ADDENDUM NO. 1

R/W Widening, Airfield Electrical and Pavement Rehabilitation (Base Bid)
Taxiway A Extension (Additive Alternate Bid No. 1)
at
Ennis Municipal Airport
Ennis, TX

TxDOT CSJ NO. 2618ENNIS

**R/W Widening, Airfield Electrical and Pavement Rehabilitation (Base Bid)
Taxiway A Extension (Additive Alternate Bid No. 1)(**

G002

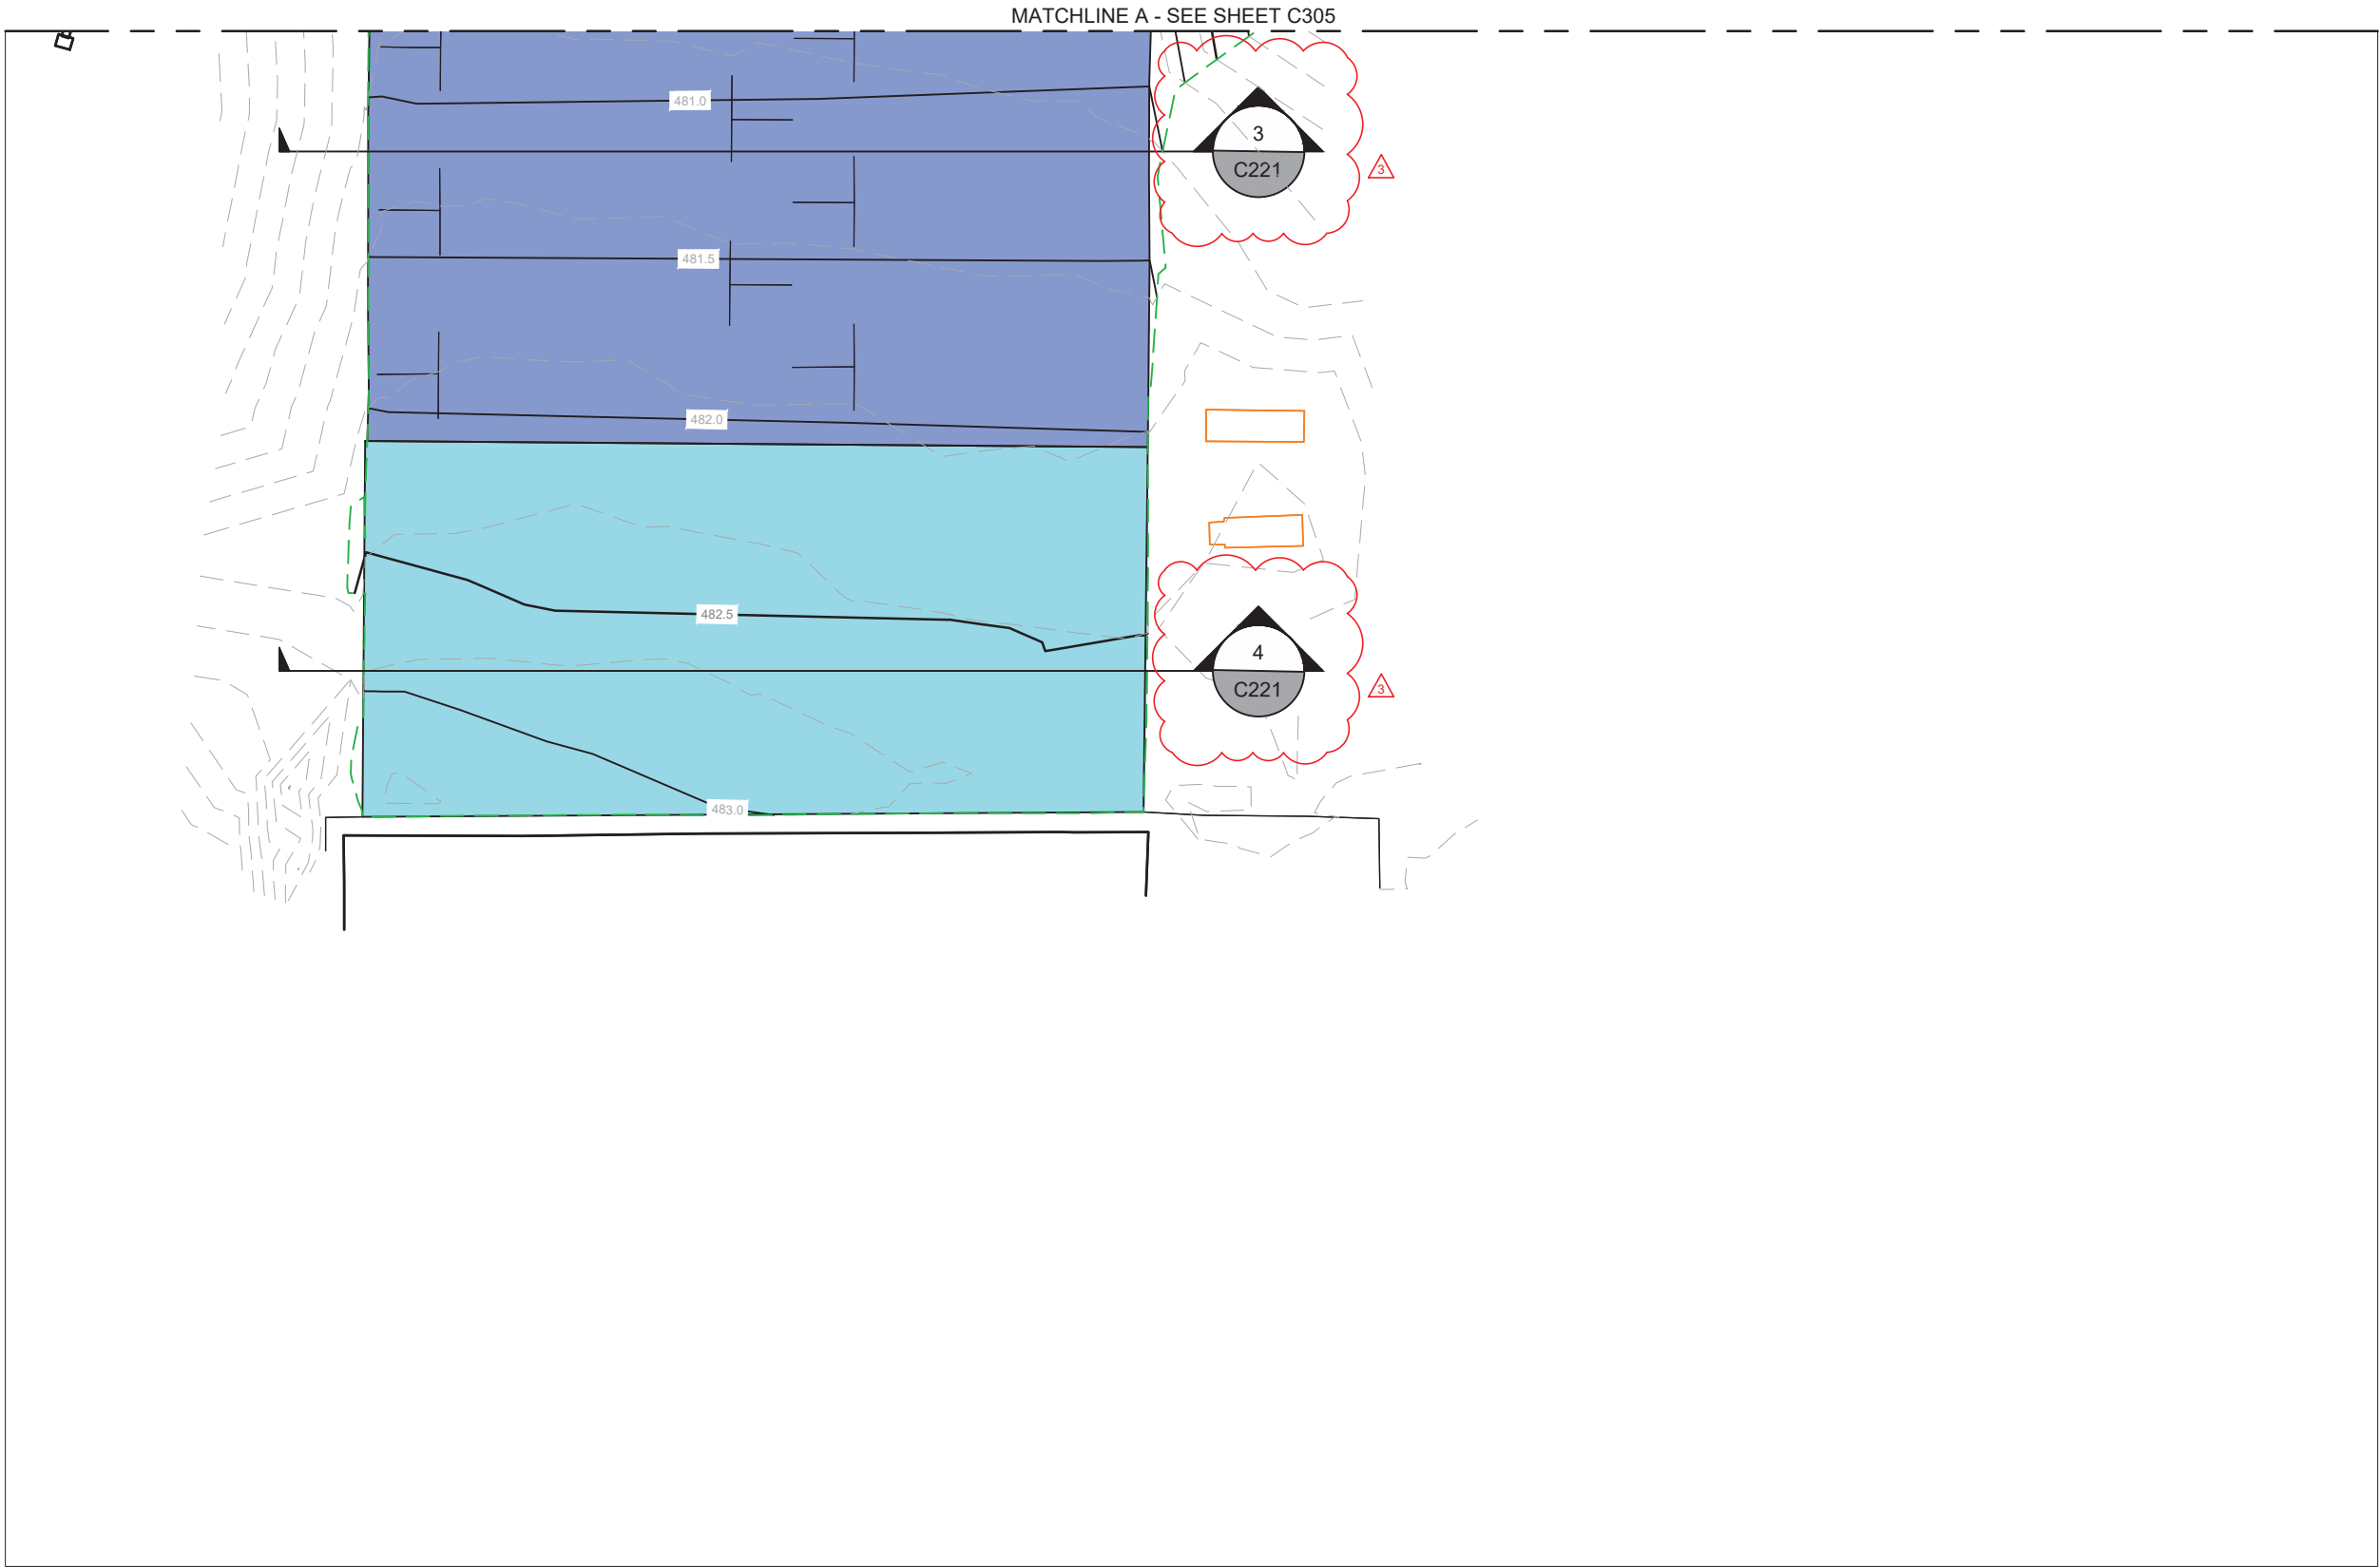
1. The following drawings were re-issued with corrections:
 - a. Sheet G002 – The Item Numbers, Descriptions and Quantities were corrected and revised to match the new Bid Form.

- b. Sheet G002 – The Index of Drawings was updated to reflect the addition of new electrical sheets.
 - c. Sheet C105A – Reversed the numbers on the typical section callouts to match the correct typical section.

SHEET NAME
C407
SHEET NO.
76 of 109

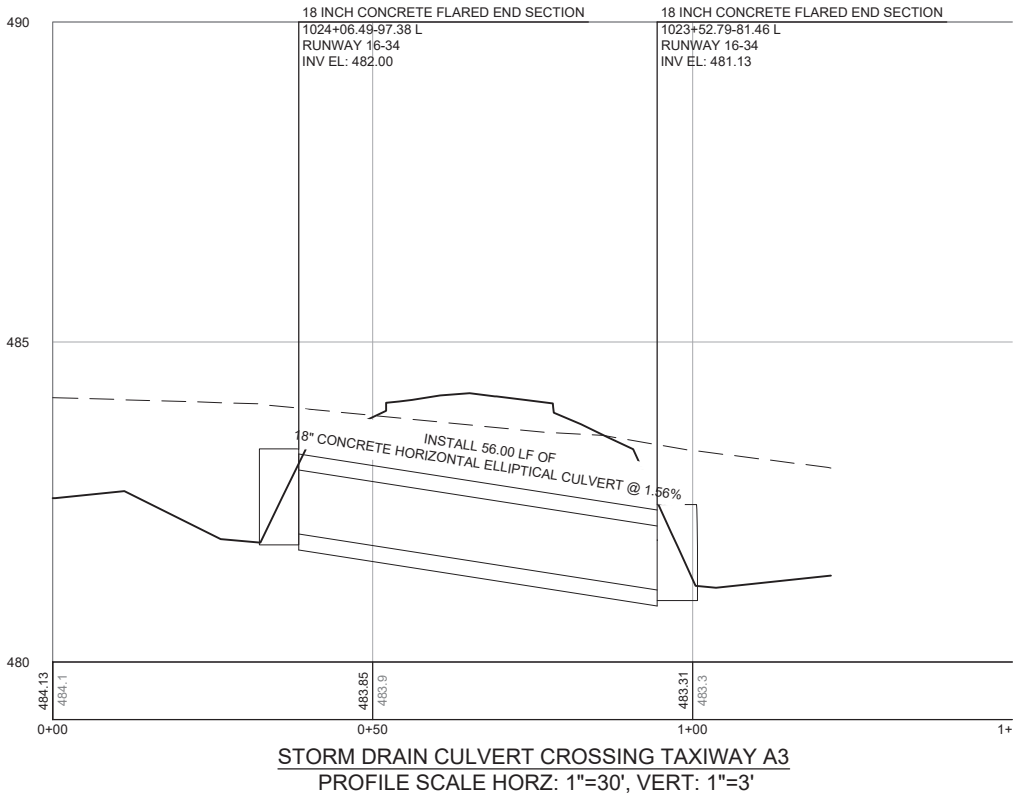
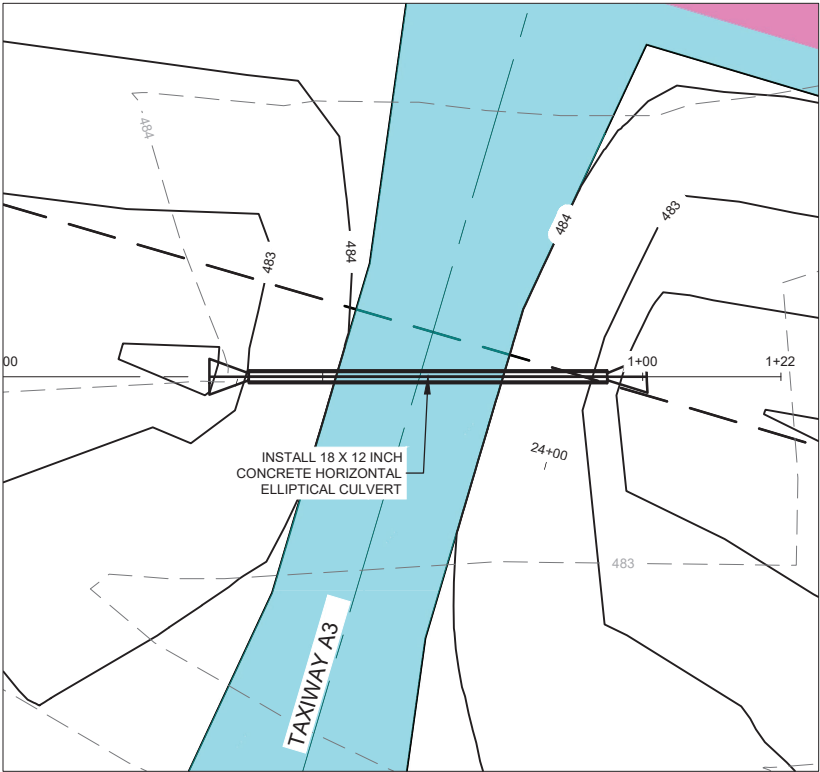
- d. Sheets C407 & C408 – Removed a 30-inch RCP and 18-in pipe extension which are not part of the project.
 - e. Sheets C501 & C502 – Removed a reference to sheets C521 and C522. C521 & C522 are not part of this project

32. Provide length, invert, profile and bedding detail for the 30-inch RCP called out on Sheet C407 and the 18-inch pipe extension on Sheets C407 and C408 and identify the pay items.

A. These RCPs were eliminated from the project and sheets C407 and C408 have been corrected and re-issued.
33. Confirm the glass bead type and application rate for P-620, and whether black border under yellow holding position markings is paid or at contractor cost (Sheet C721 Notes 14 and 15).

SHEET NAME
C501
SHEET NO.
80 of 109

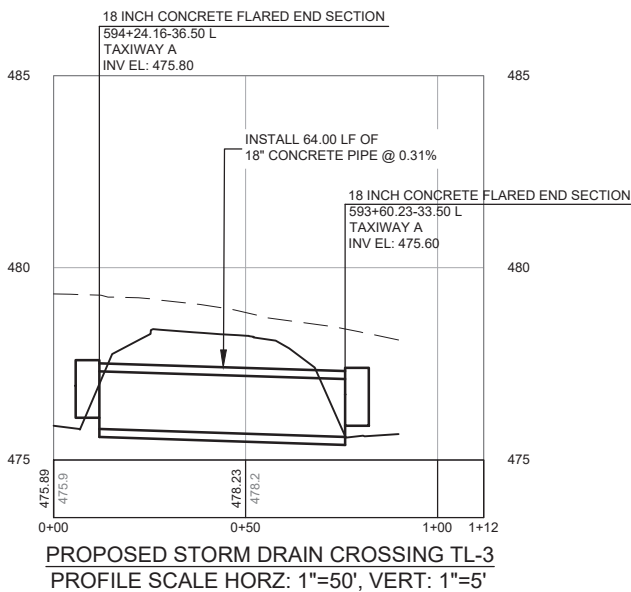
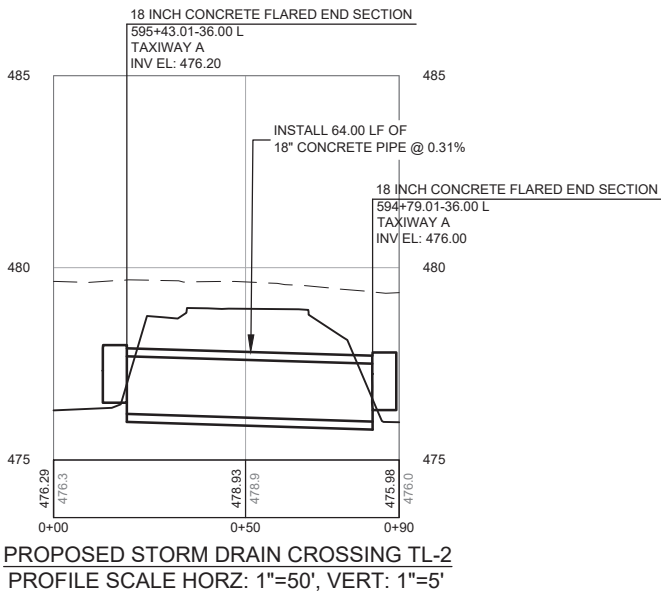
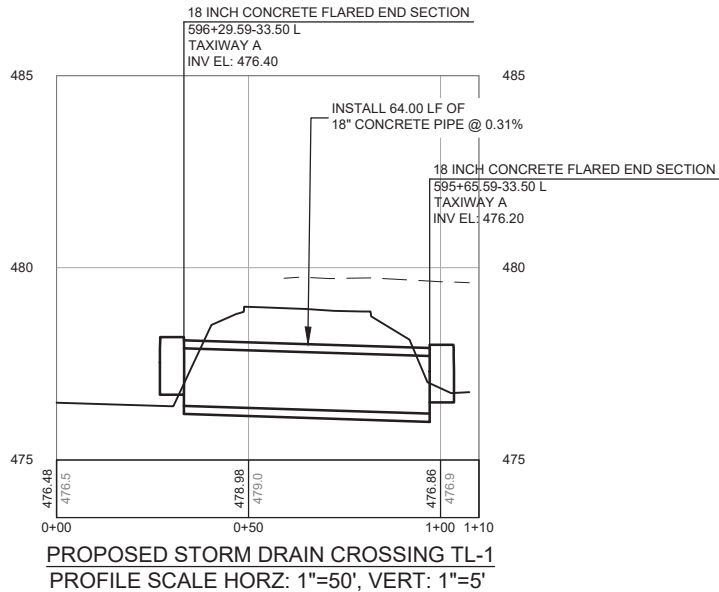
A. Add Alternate 1, if awarded, is concurrent with Phase 1. No additional mobilization will be added.
30. Provide drainage detail sheets C521 through C522, referenced on Sheets C501 and C502 but not in the set.

A. The note on Sheets C501 and C502 are erroneous. These sheets have been corrected and re-issued.
31. Provide the runway centerline stripe spacing sheet referenced as "SHEET ####" on Sheets C701 through C709, and the matchline sheet reference on Sheet C306.

PAVEMENT MARKING PLAN
STA. 1042+61.82 TO STA. 1038+00
RUNWAY 16/34

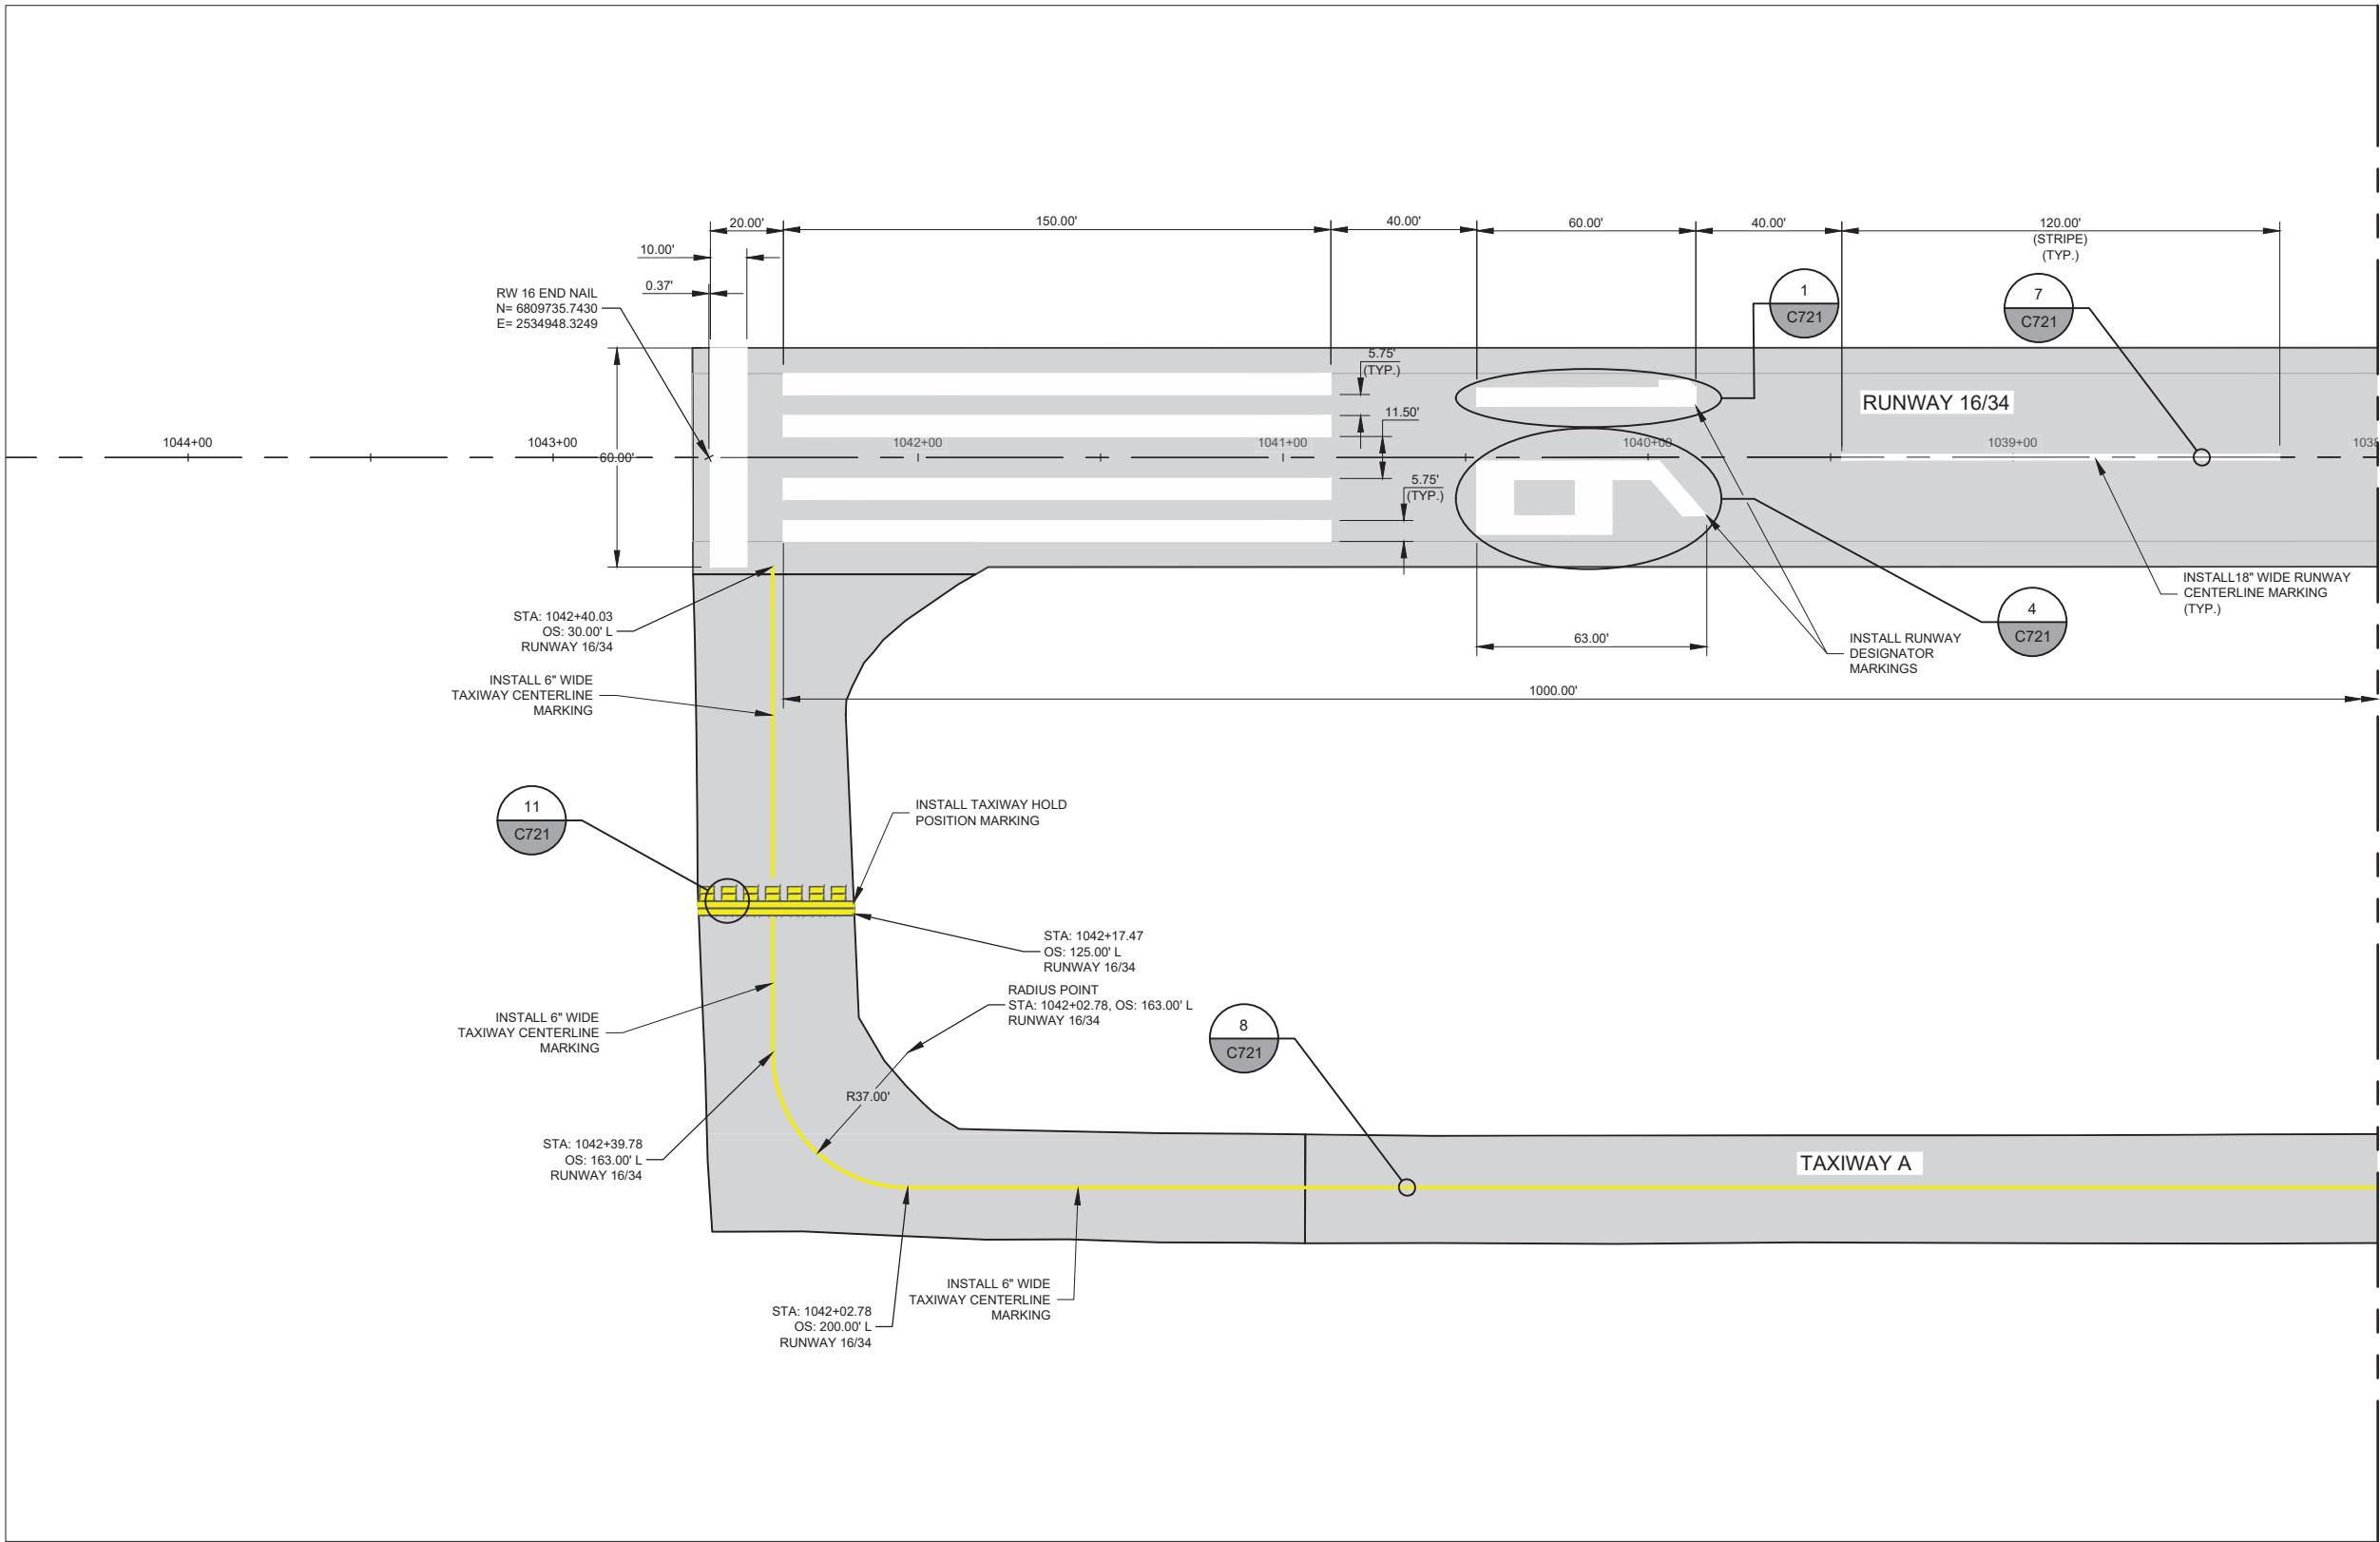
- f. Sheets C701 through C709. – Removed a reference to centerline stripe spacing as shown on SHEET #####. The centerline stripe spacing is shown on C701 through C709.

A. This reference is in error and has been removed. Centerline stripe spacing can be found on the pavement marking plans. No additional sheets are required.
